ADDENDUM NO. 02

Project:
Sheridan HS and MS School Renovation Project

Owner:
Sheridan Community Schools
24795 Hinesley Road
Sheridan

This Addendum #02, Dated 09.12.2025, forms part of the contract documents and modifies the original Bidding Documents dated 08.15.2025. Please acknowledge receipt of this Addendum in the space provided on the Bid Form. Failure to acknowledge this Addendum may subject the Bidder to disqualification.

DRAWING NUMBER
A201B

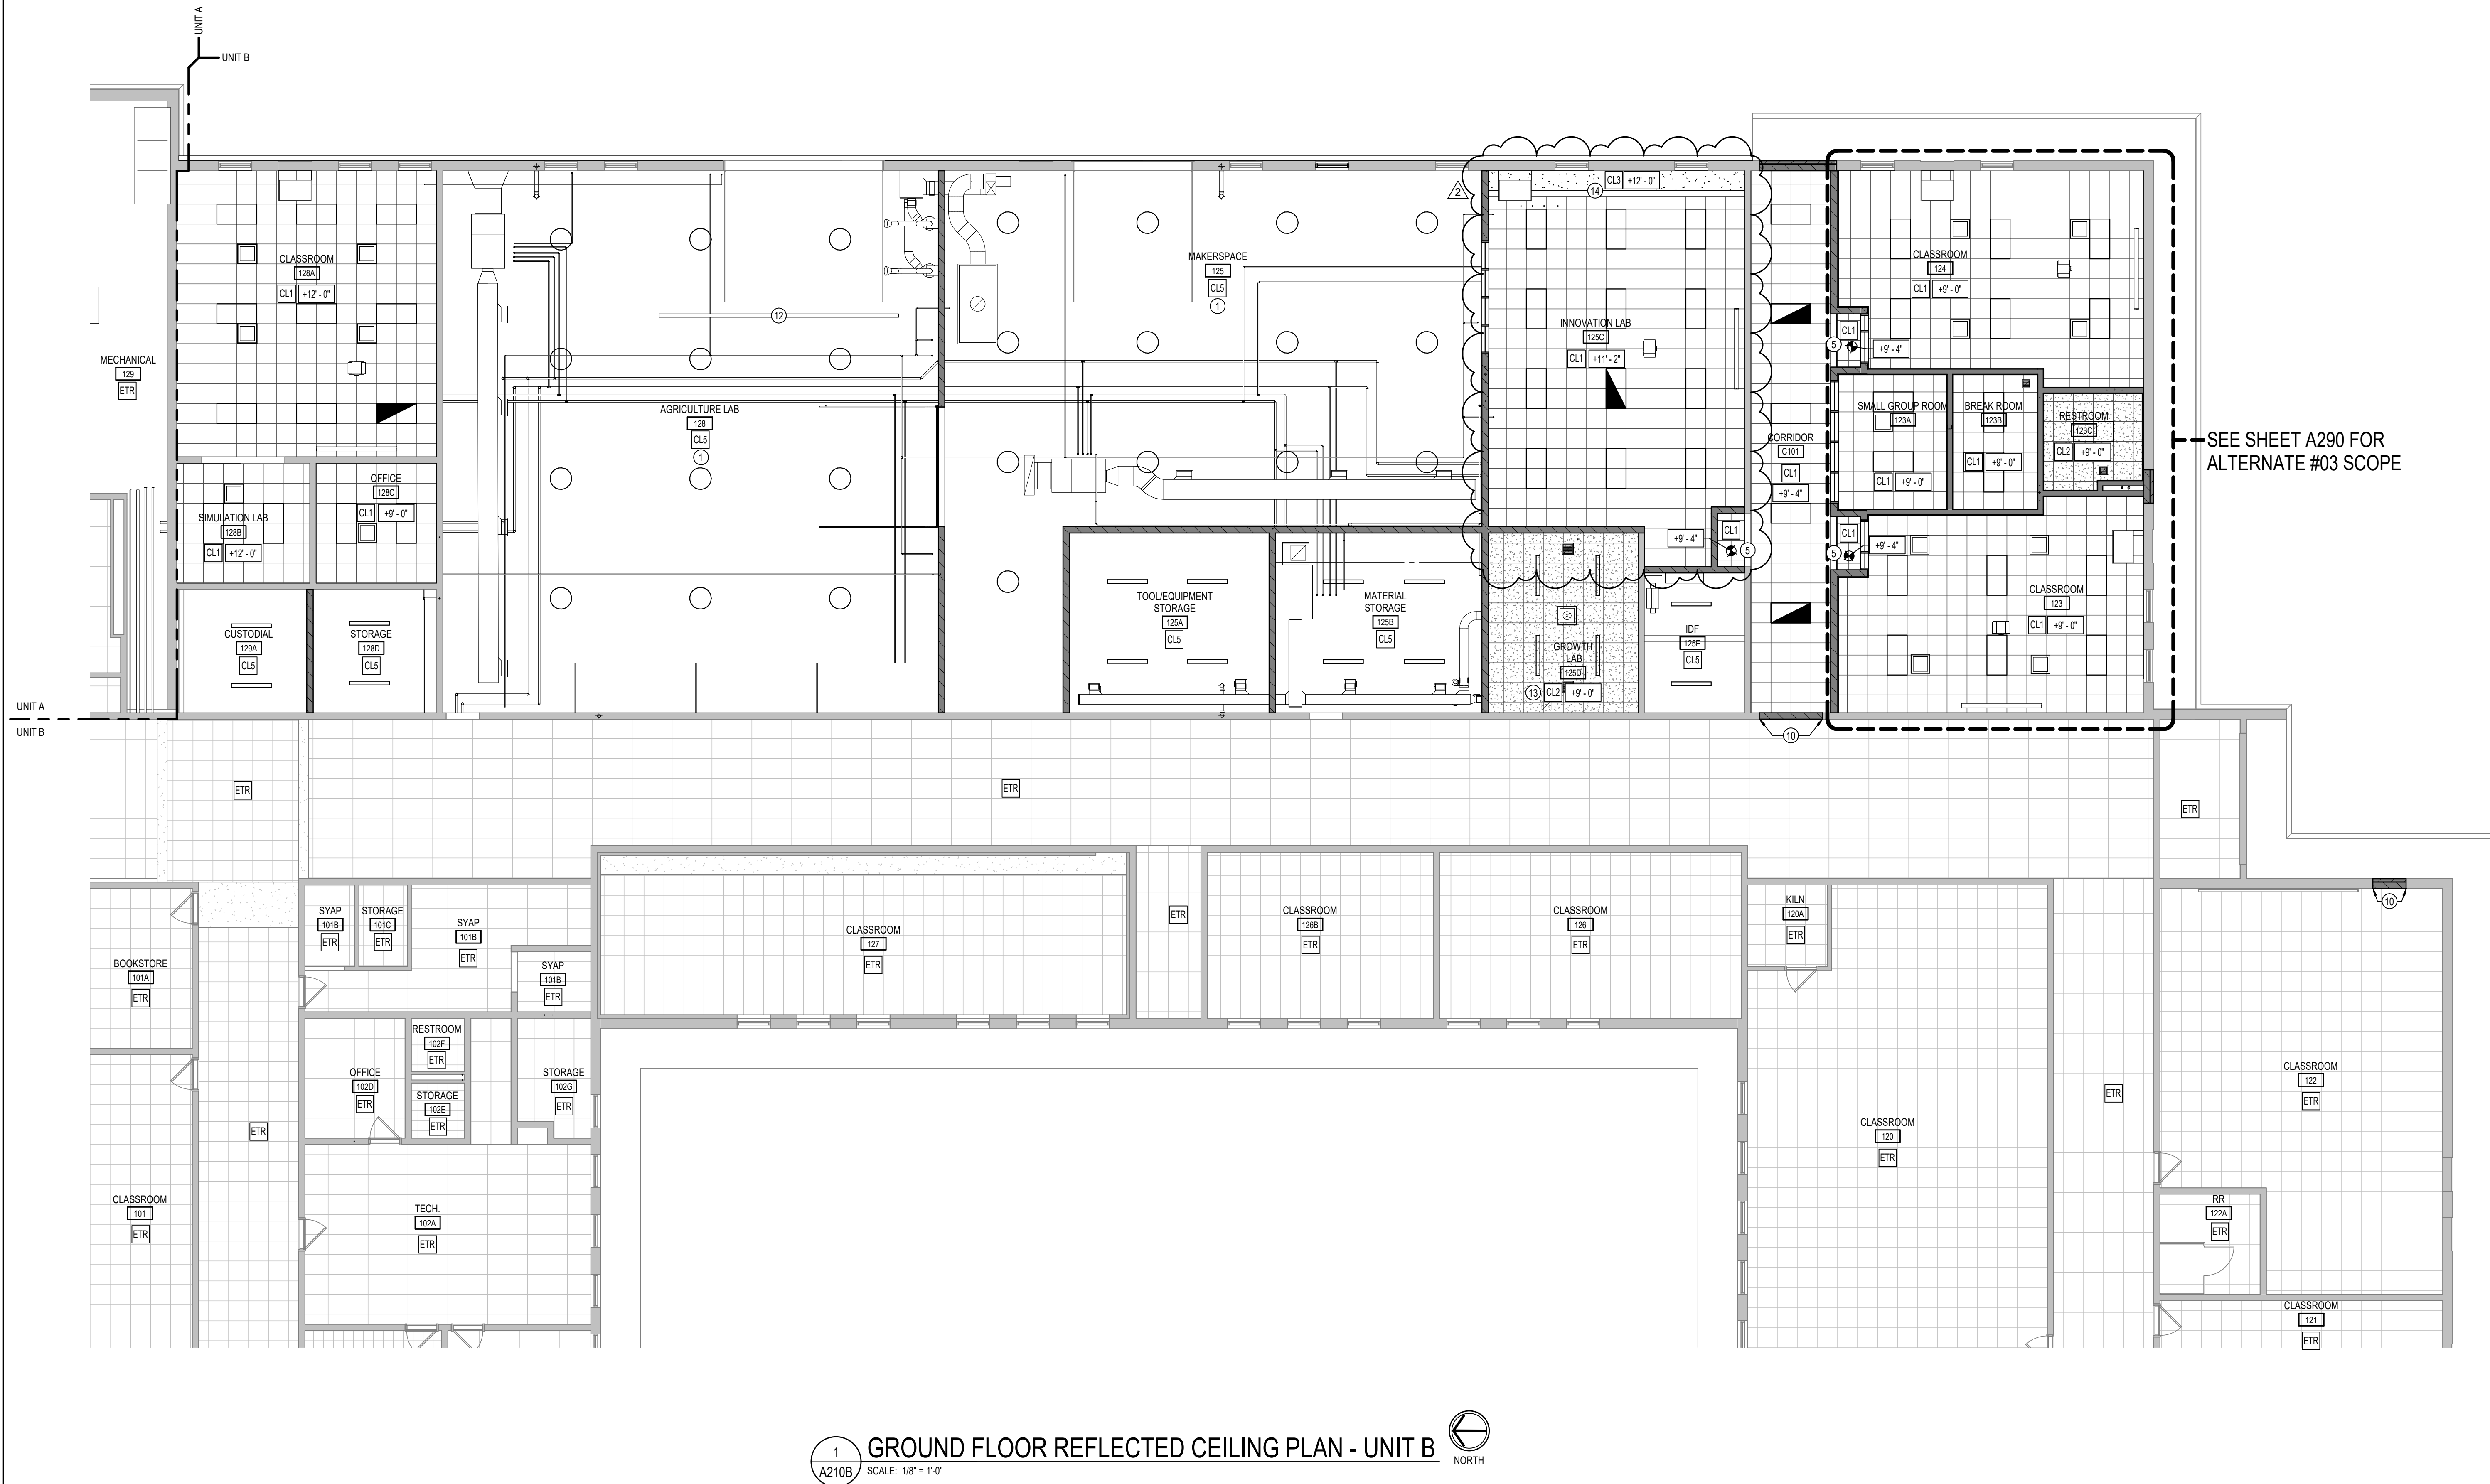
- A. Add Plan Note 14
- B. Add Plan Note 15.
- C. Add plan notes 14 and 15 to plan as shown.
- D. General note M changed to "NOT USED".

7. All Contractors shall review and include your work per the Added Plan Note 14 and 15 on A201B.
8. Bid Item #06 Drywall Contractor shall furnish and install the bulkhead per Detail 3 on Drawing A210B and per RCP Note 14 on A210B. Bid Item #07 Painter shall provide the associated Painting Work.

6 INNOVATION LAB 125C - NORTH
A601 SCALE: 1/4" = 1'-0"

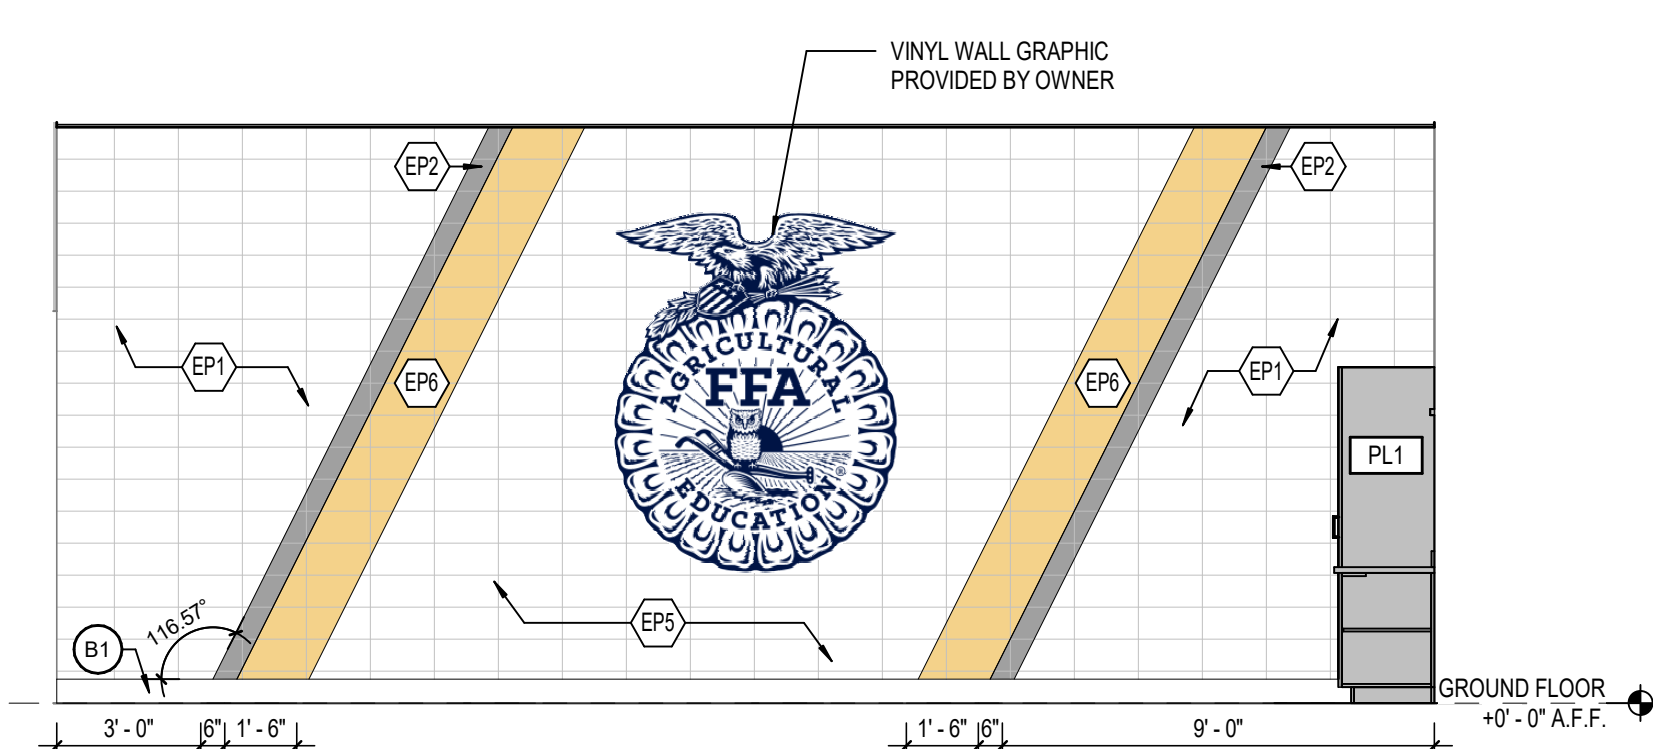
- A. Revised Elevation numbers.
- B. Add Elevation 6/A601.

LVT TO EXISTING TERRAZZO

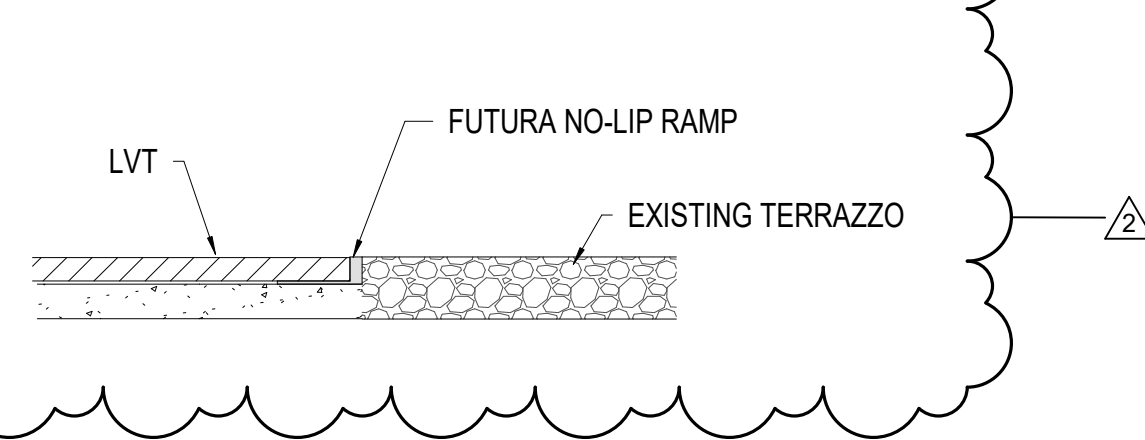
- A. Revised LVT to Existing Terrazzo transition strip.

9. Bid Item #10 Carpet, LVT and Base Work Contractor shall furnish and install the floor grinding and metal transition work per Finish Plan Note F16 and revised transition detail on A800 and A801A.

1
A801A

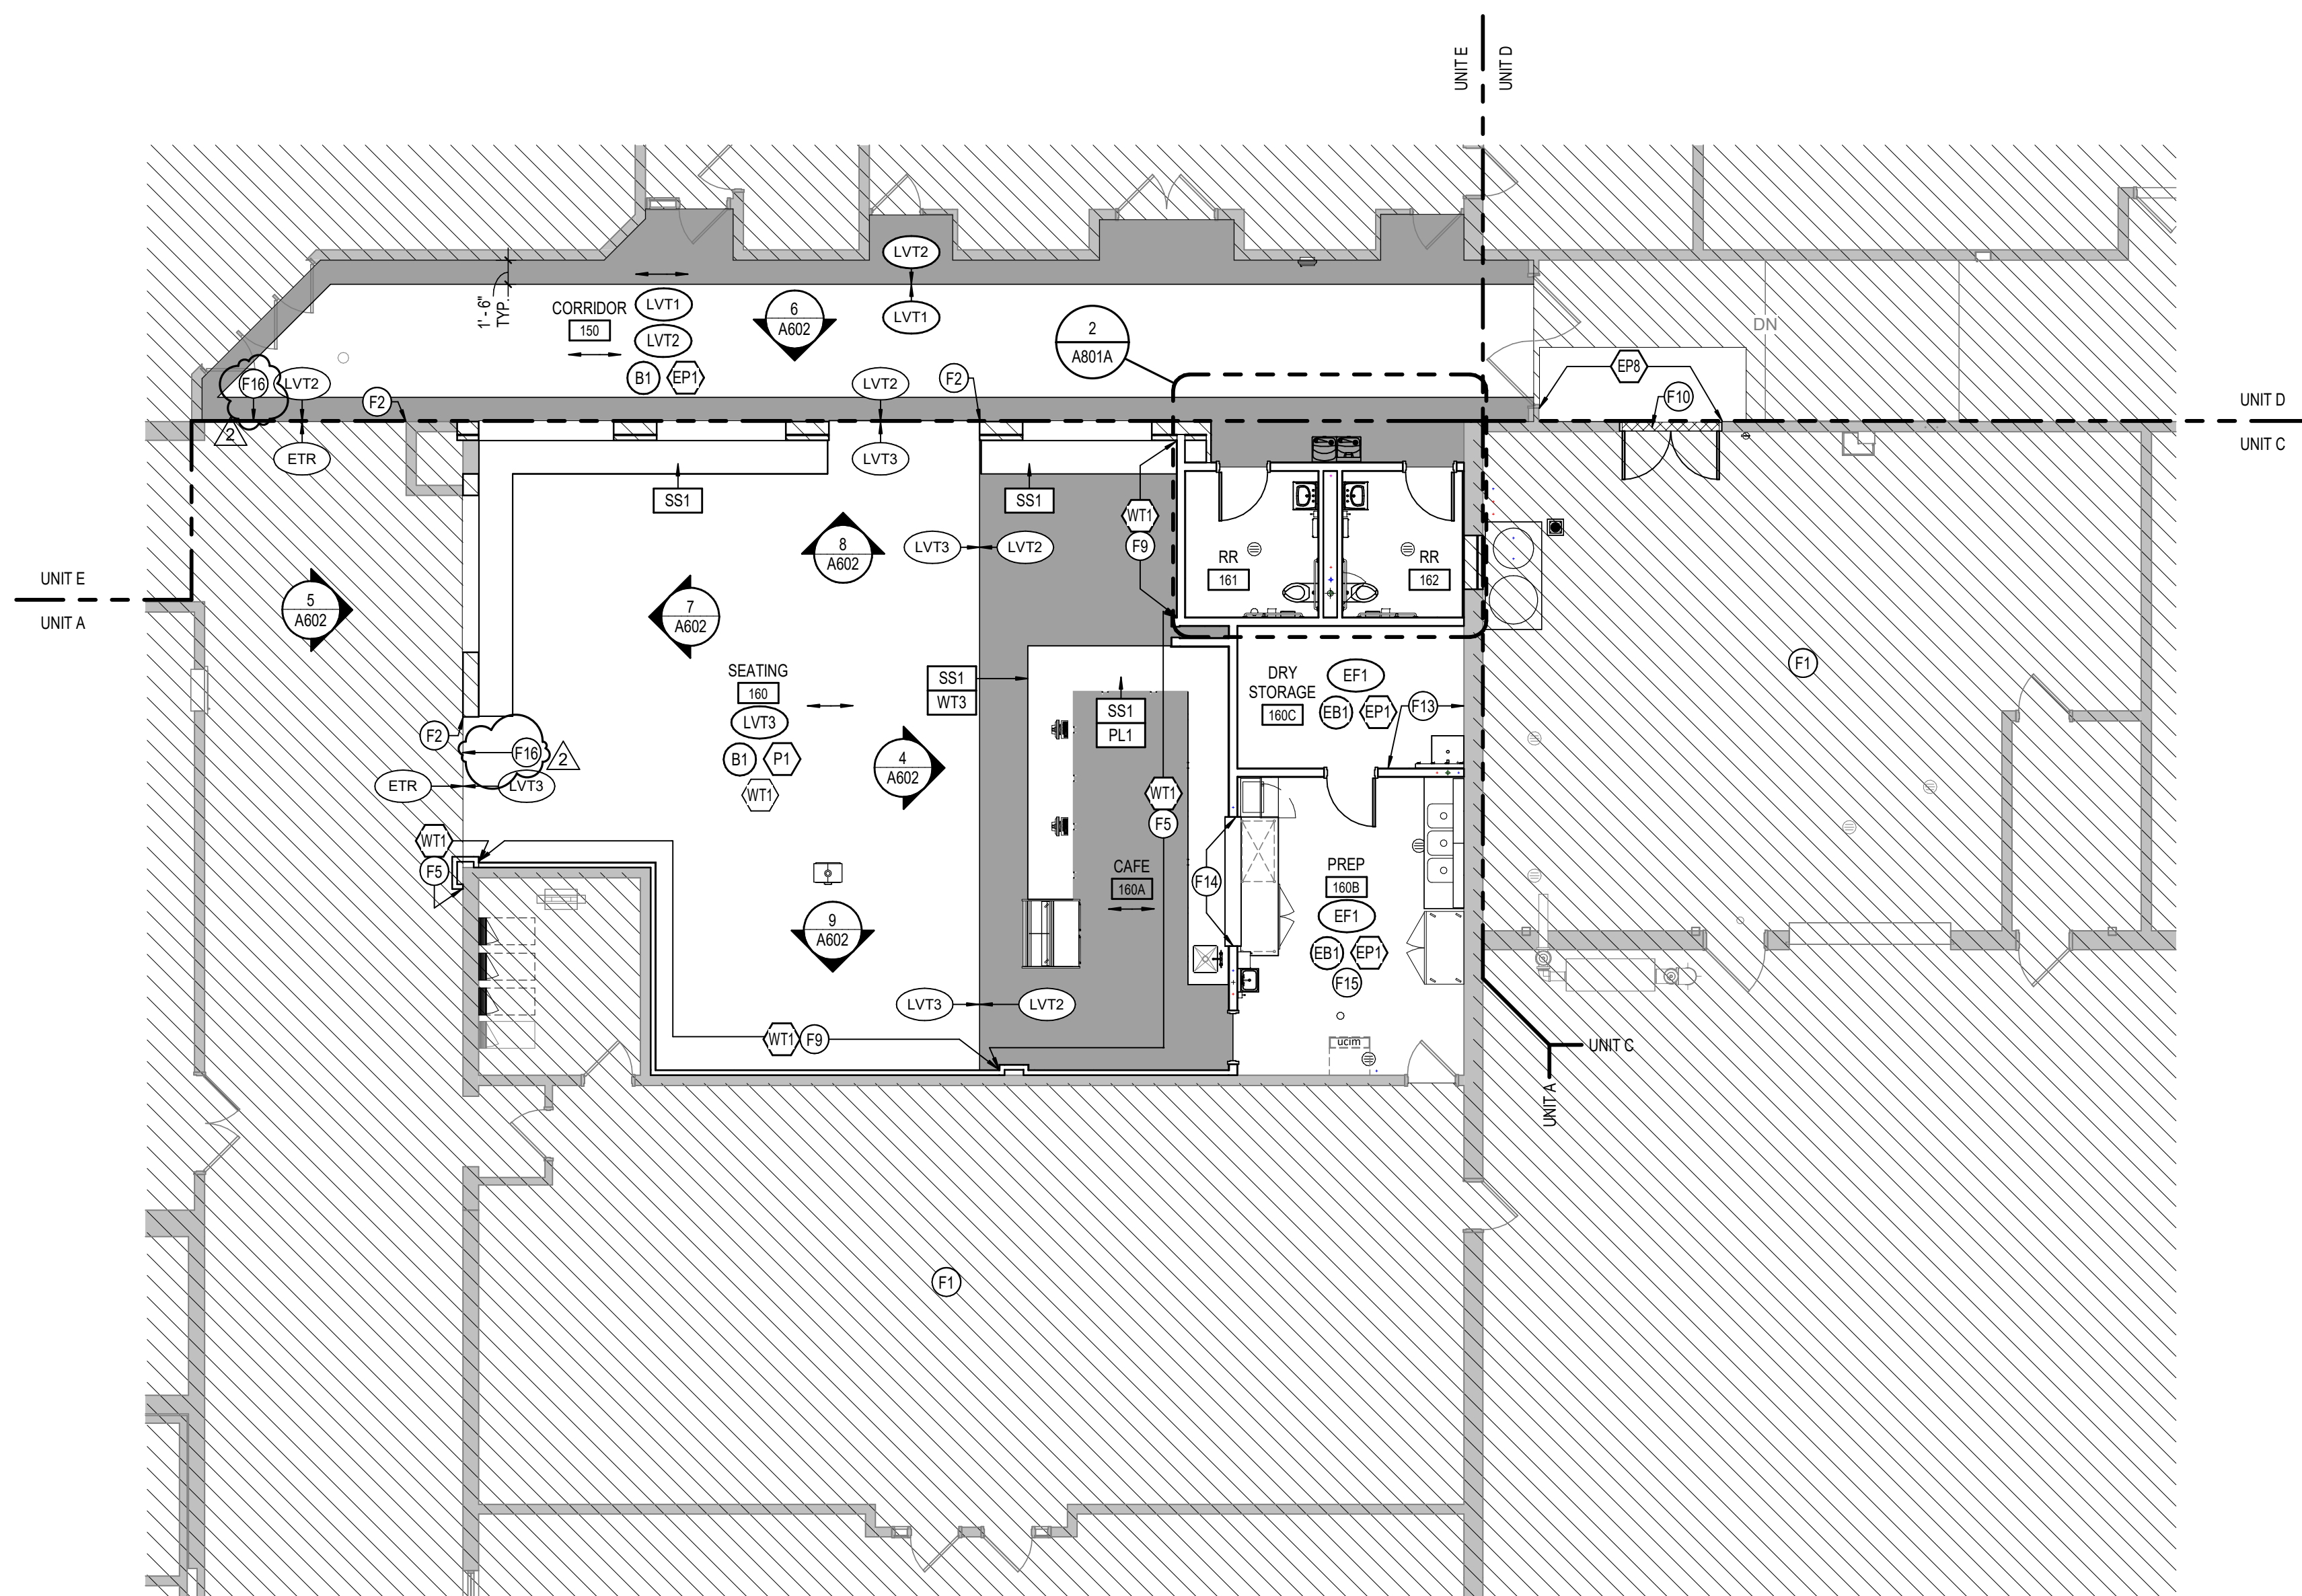
- A. Add F16 to finish note list.
- B. Add F16 to plan as shown.
